PLANNING AND DEVELOPMENT SERVICES STAFF REPORT

For Planning Commission Meeting of December 20, 2011

**SUBJECT: Traver Village Site Plan for Planning Commission Approval
(2601 Plymouth Road)
File No. SP11-032**

LANDSCAPE PLAN

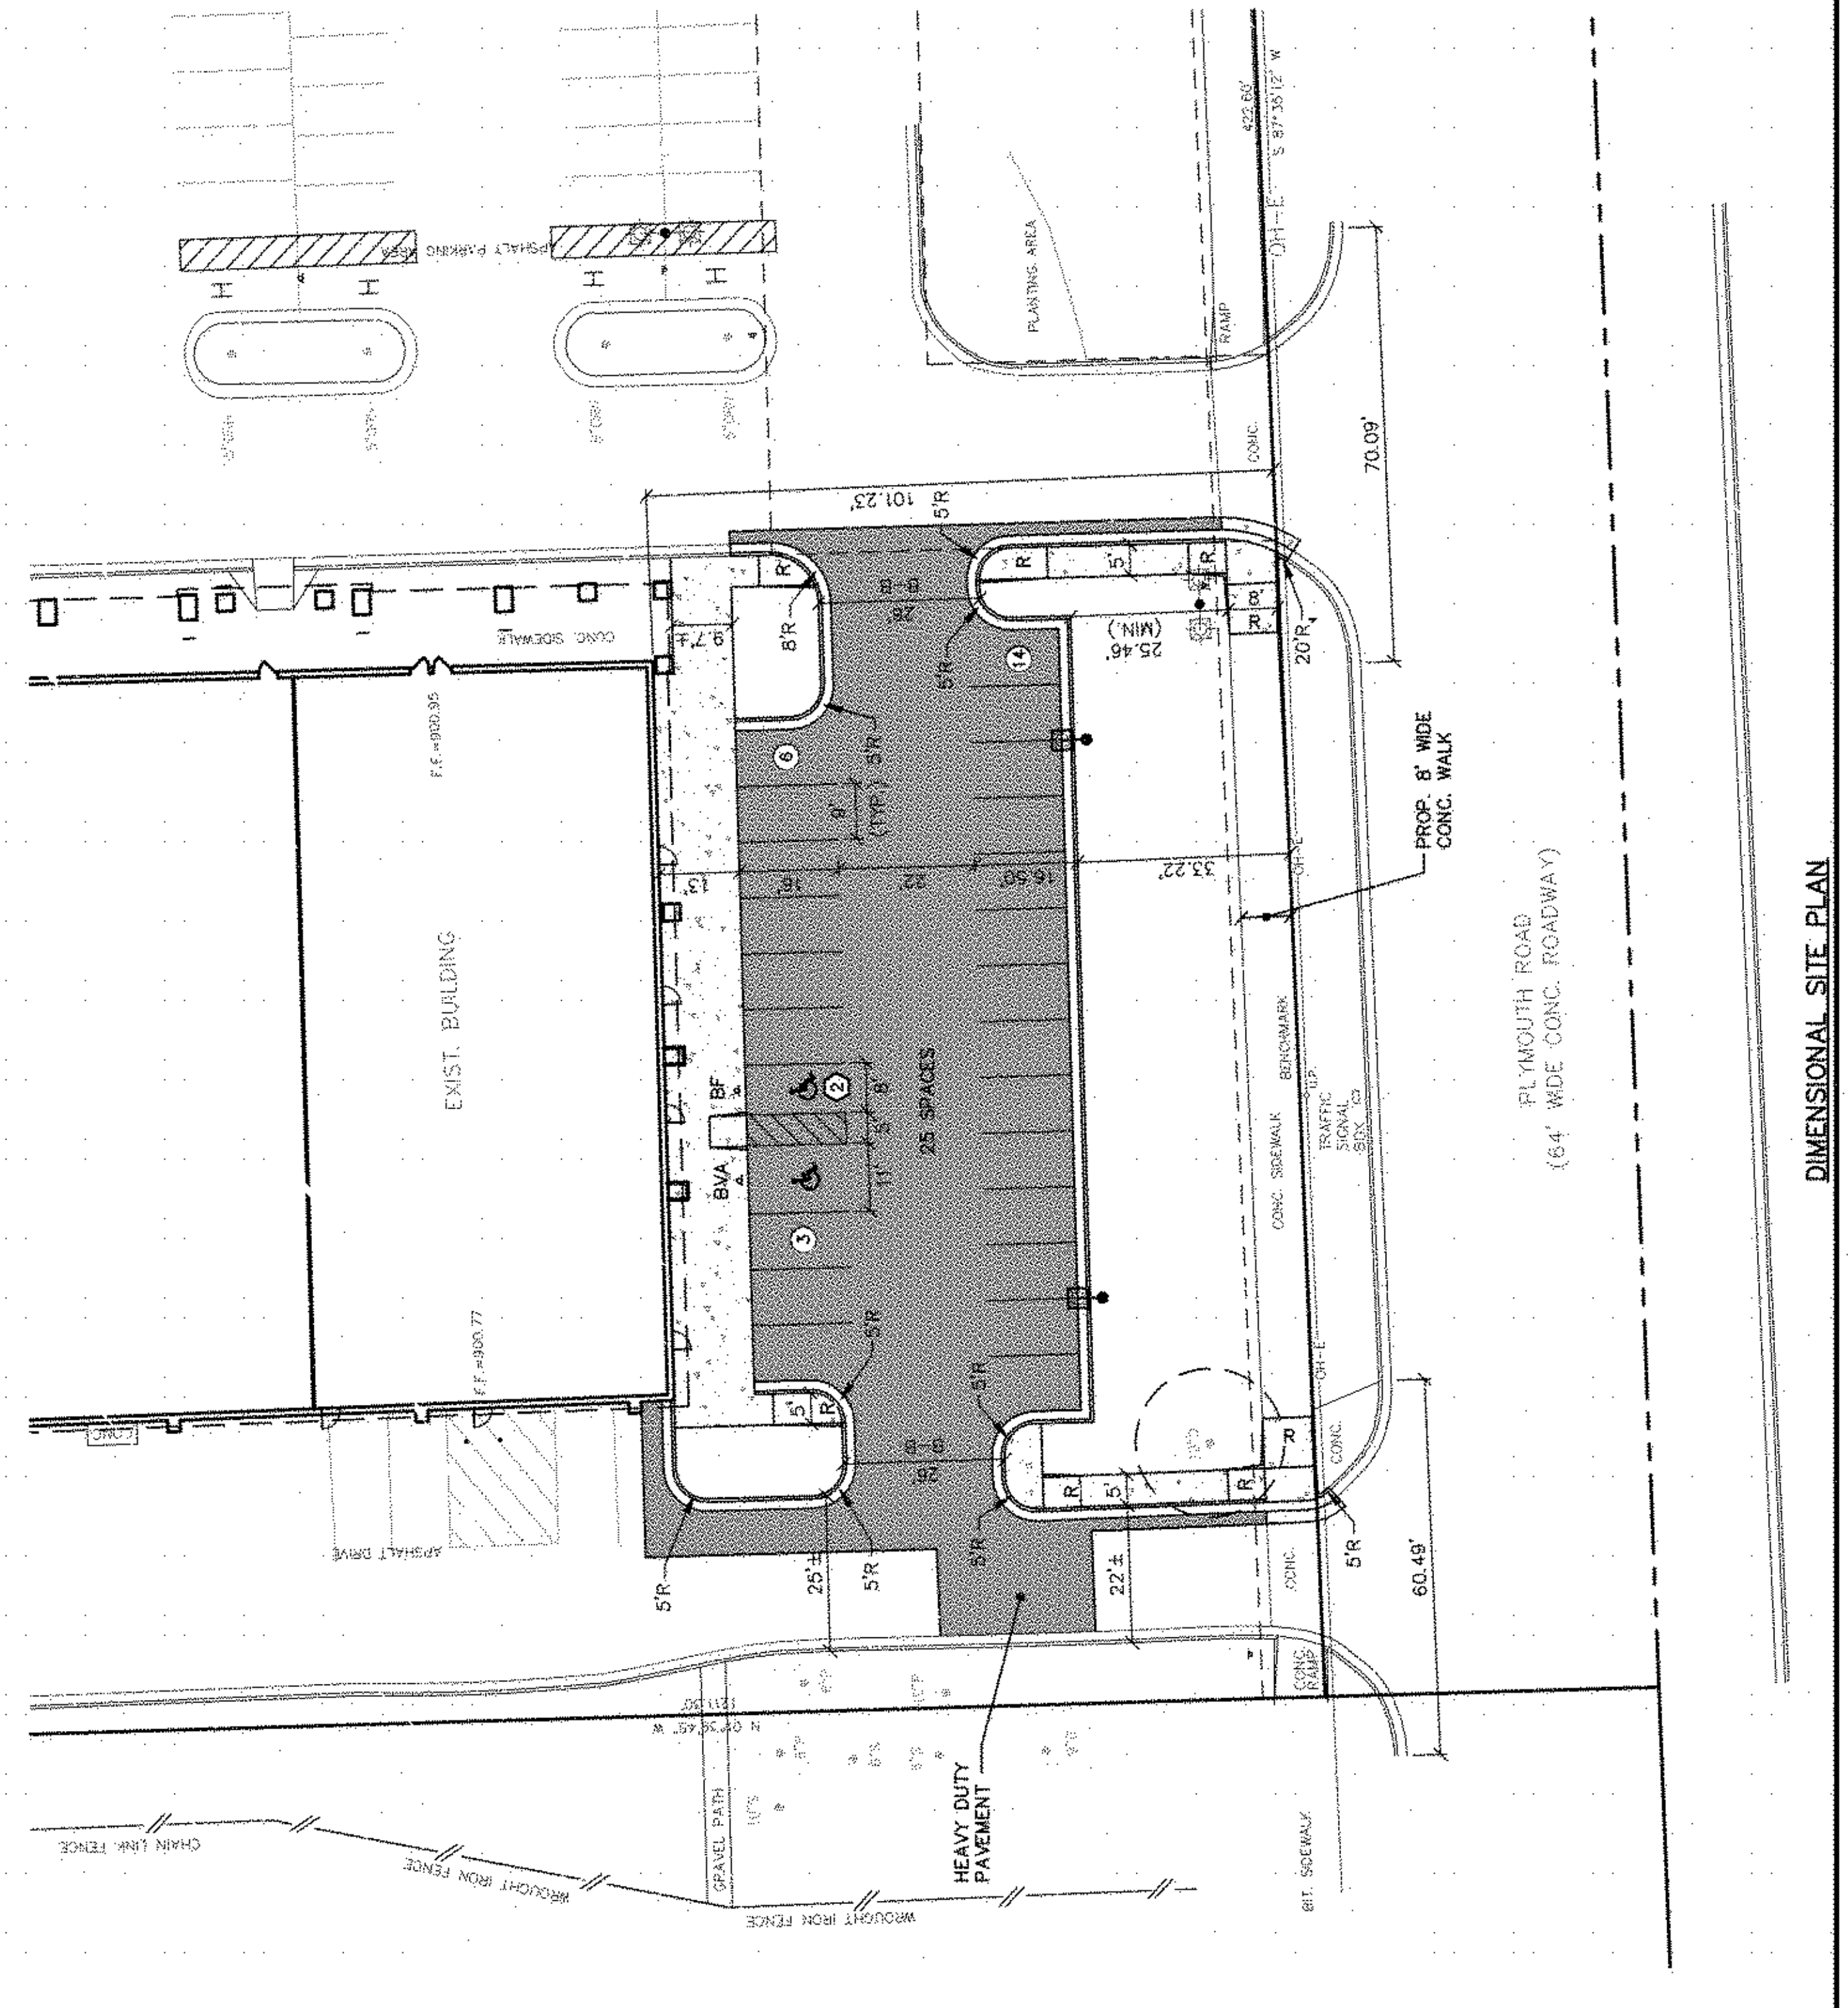
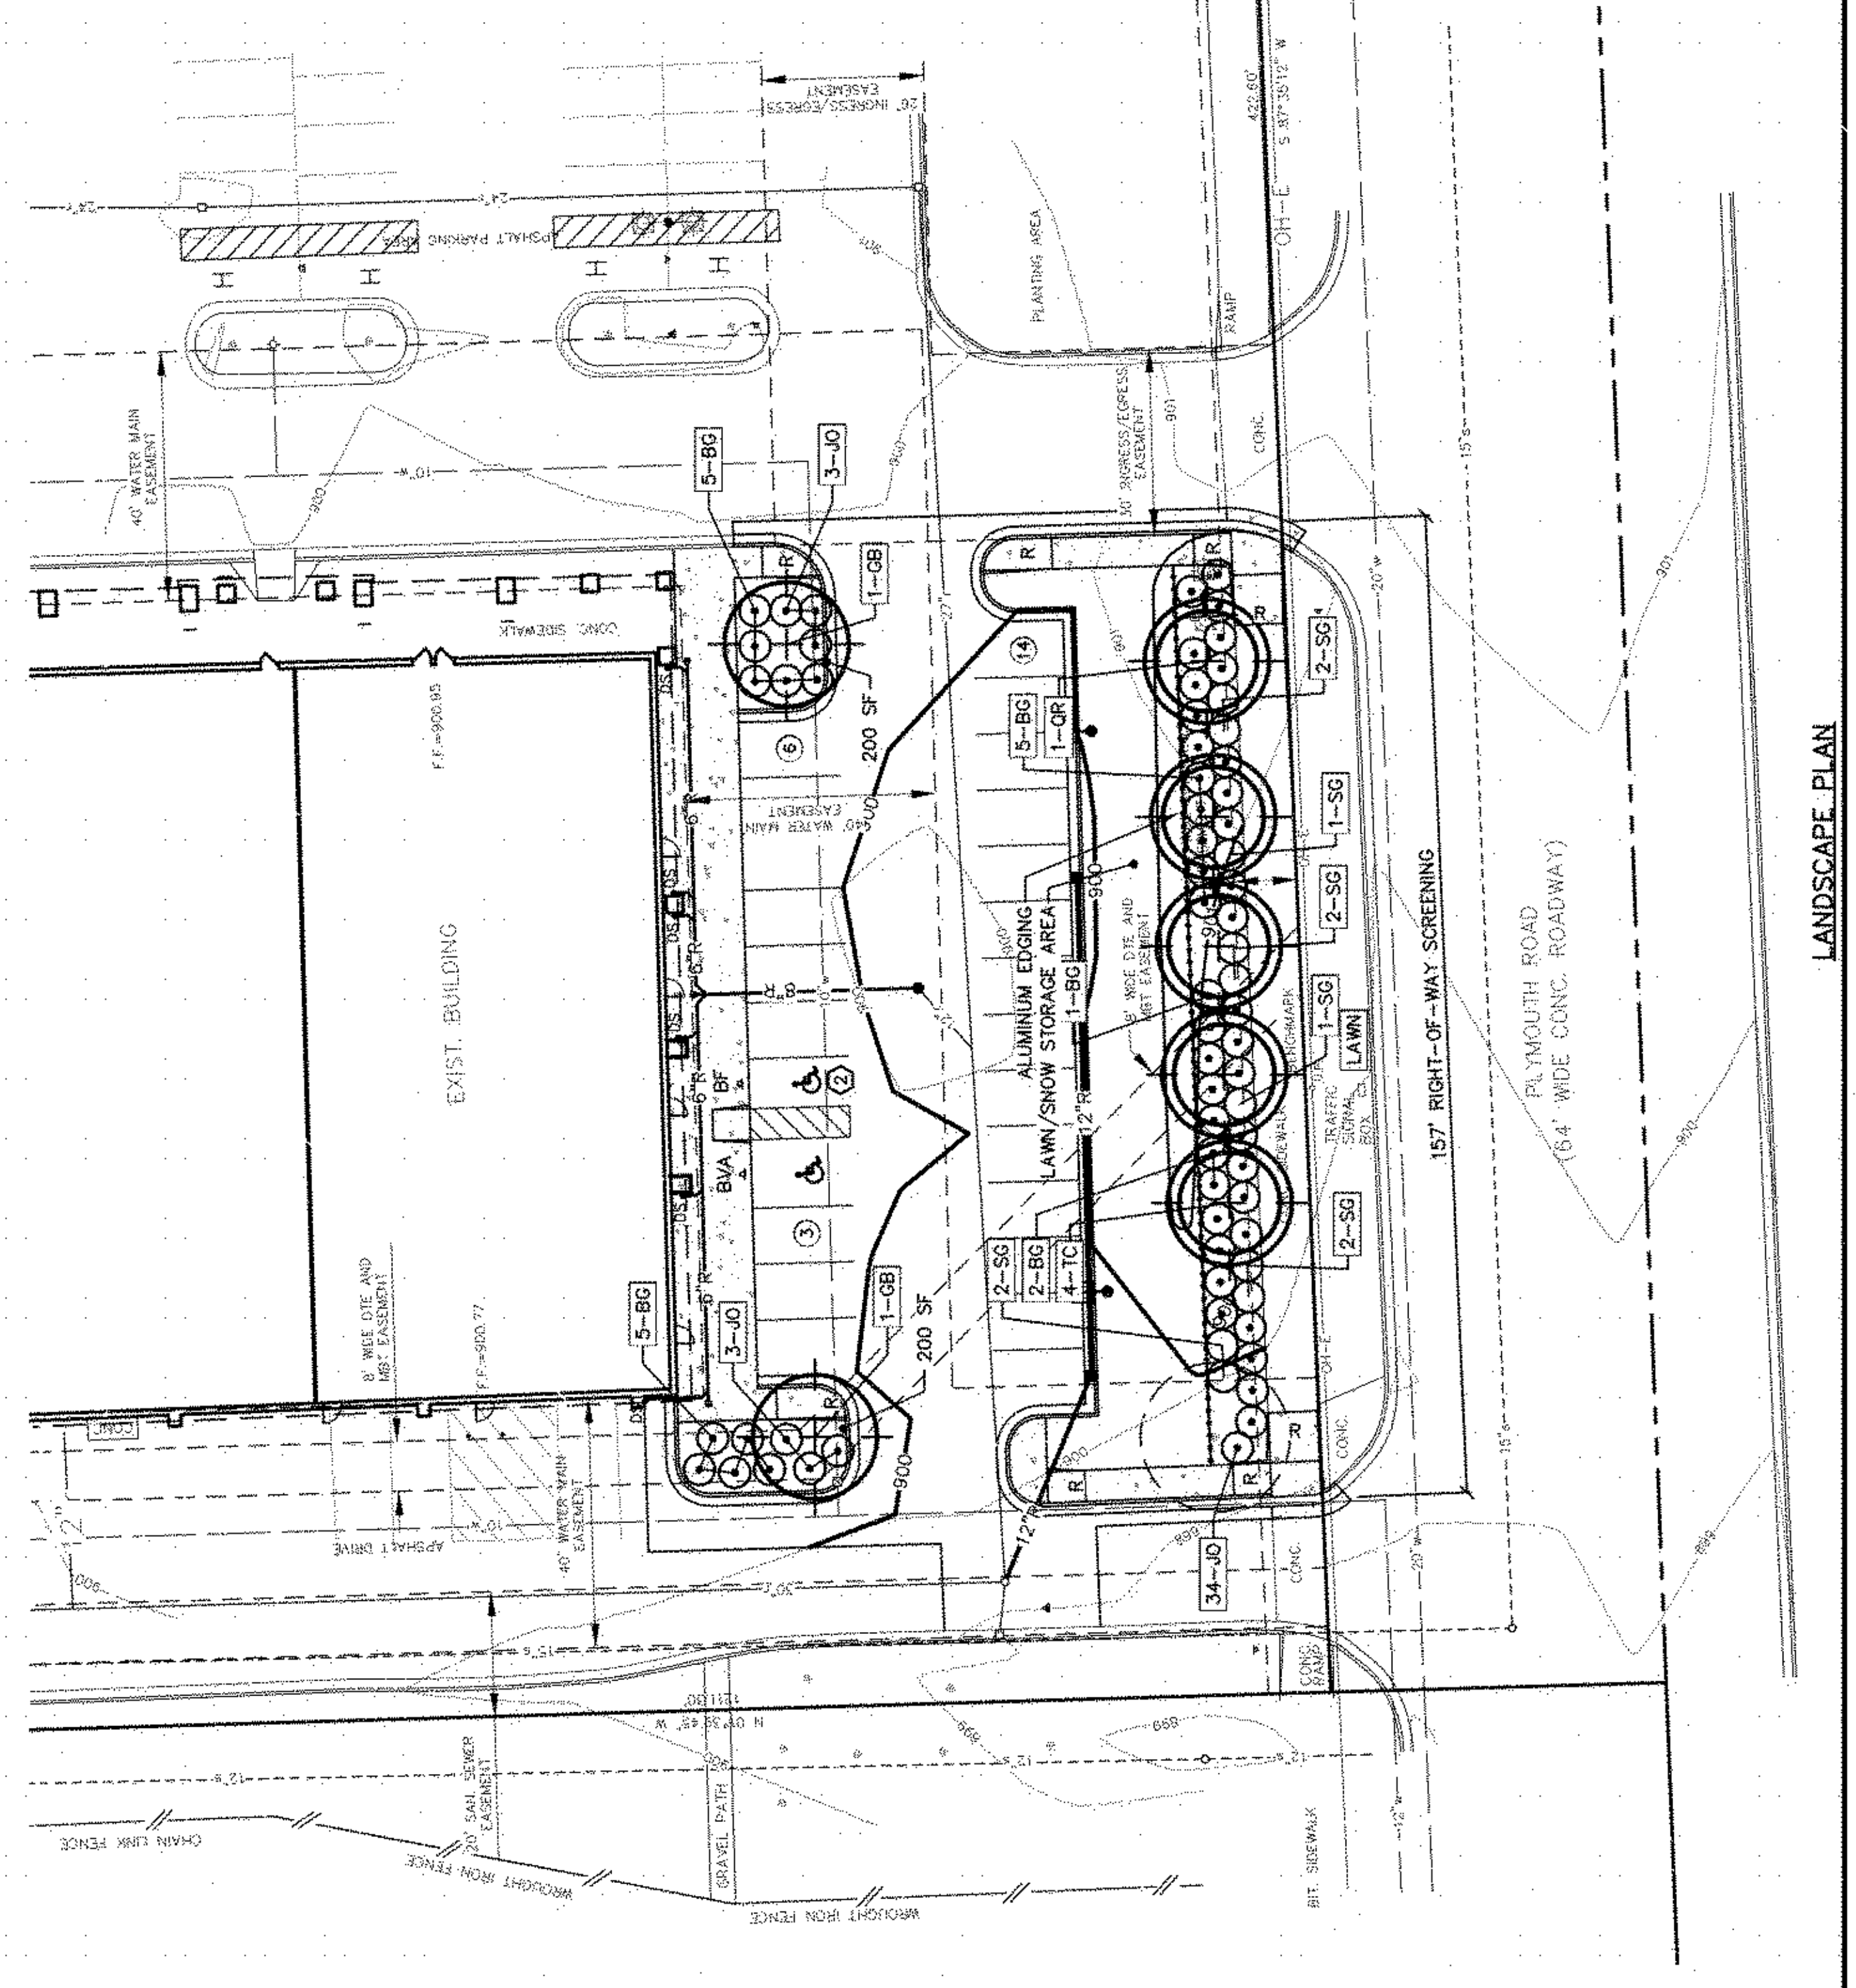
Staff recommends that the petitioner provide four street trees in the lawn extension adjacent to the new parking lot along Plymouth Road. The petitioner plans to remove 13 older evergreen trees and provide seven new 2-inch caliper trees for the right-of-way screening requirement. The addition of four street trees will help mitigate the visual impact of the loss of the evergreen trees and the construction of the new parking lot.

Systems Planning (Forestry) –The developer is requesting a modification of Chapter 62 to keep existing tile mulch in landscape islands where Chapter 62 requires the use of organic mulch. Organic mulch decomposes, which improves soil quality and fertility, while stone mulch does not. In addition, organic mulch will retain soil moisture not just allow infiltration, soil moisture is critically important for plant survival especially in landscape islands. Staff supports the proposed modification to retain the existing crushed tile mulch and replace it with organic mulch when trees are replaced. This support is conditional on the replacement of the 21 interior landscaping trees that were evaluated at less than 50% health.
